Access Compliance Report

Public Rights-of-Way

(Pedestrian Signals)

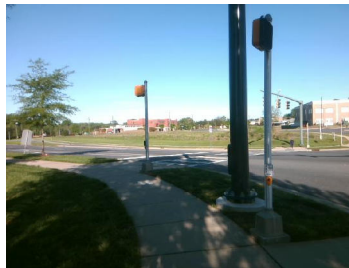
PROW/ADA: TMUTCD 4e.08, R404.2, R404.3, R406.2, R209.1, MUTCD 4e.10

Possible Solutions: Replace Signal Push Button With APS Button on New Post. Remove & Relocate Sign.
